Project Design Comparison

April 2016
CIP

MIAMIBEACH

Revised & Value Engineered Scheme March 30, 2016 (60% Design Phase)

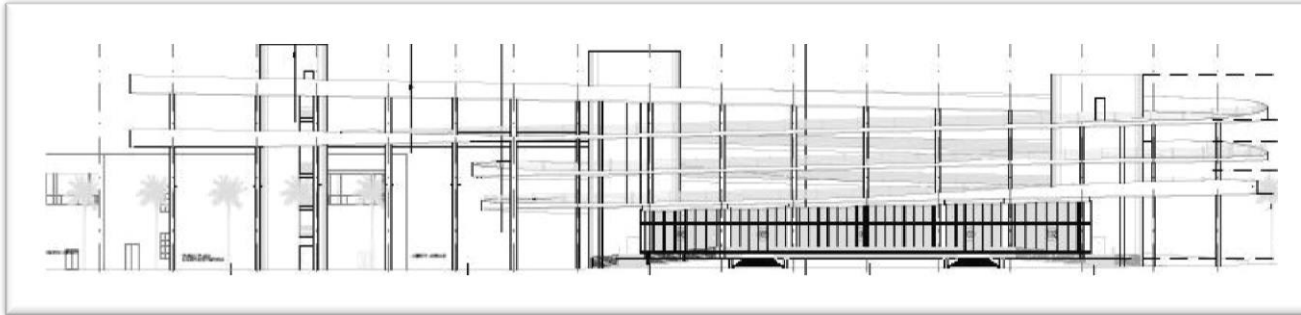
- Facchina Cost - \$24,887,830
- 409 Parking Spaces
- 8,102 sq.ft. Retail Space
- Public Plaza Reduced
- Ground Floor Parking Added
- Minimized connectivity to Liberty Ave.

- Facchina Cost - \$48,989,044
- 466 Parking Spaces
- 16,390 sq.ft. Retail Space
- 15,850 sq.ft. Public Plaza
- Architectural Curved Stairs
- Liberty Ave. Connectivity to Collins Park

Revised & Value Engineered Scheme – March 30, 2016

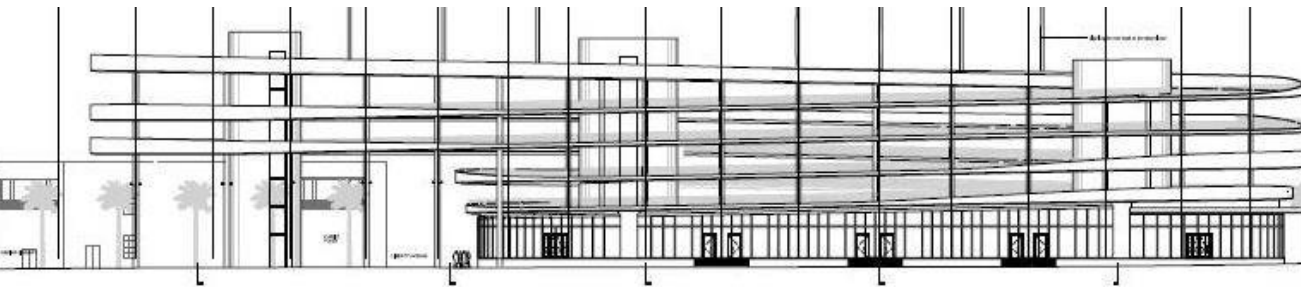
- Cost - \$24,887,830
- 409 Parking Spaces (4 level parking)
- 8102sq.ft. Retail space
- Small Public Plaza
- Stairs Modified with Simple Switch-Back Concrete Enclosure
- Roof Pavilion Eliminated (Stair and Elevator Enclosures)
- Grid / Column Layout Regularized
- Balustrades Greatly Simplified
- Landscape Design Eliminated

Case Study Scheme – February 22, 2016

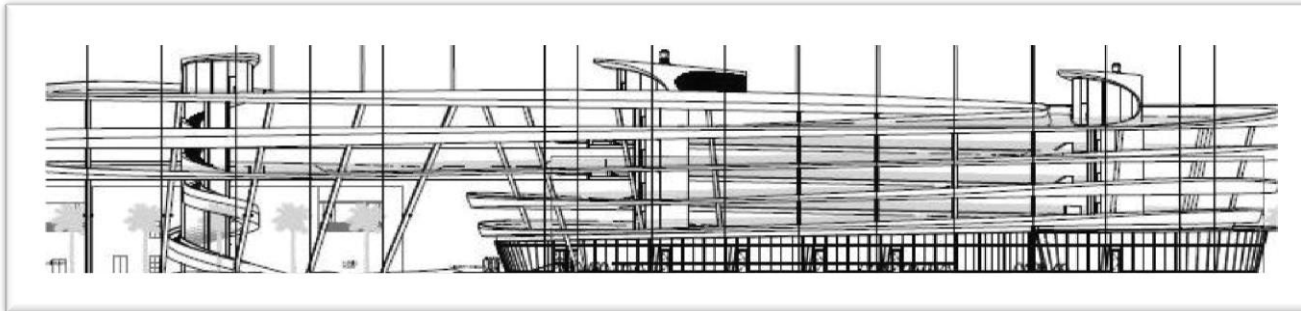
- Cost - \$31,269,747 \$29,387,635 (Rev. 3/9/16)
- 466 Parking Spaces (5 level parking)
- 16,390sq.ft. Retail space (Include east and west retail retail areas)
- 15,850sq.ft. Public Plaza with Plain Concrete
- Stairs Modified with Simple Switch-Back Concrete Enclosure
- Roof Pavilion Eliminated (Stair and Elevator Enclosures)
- Grid / Column Layout Regularized
- Balustrades Greatly Simplified
- Landscape Design Eliminated
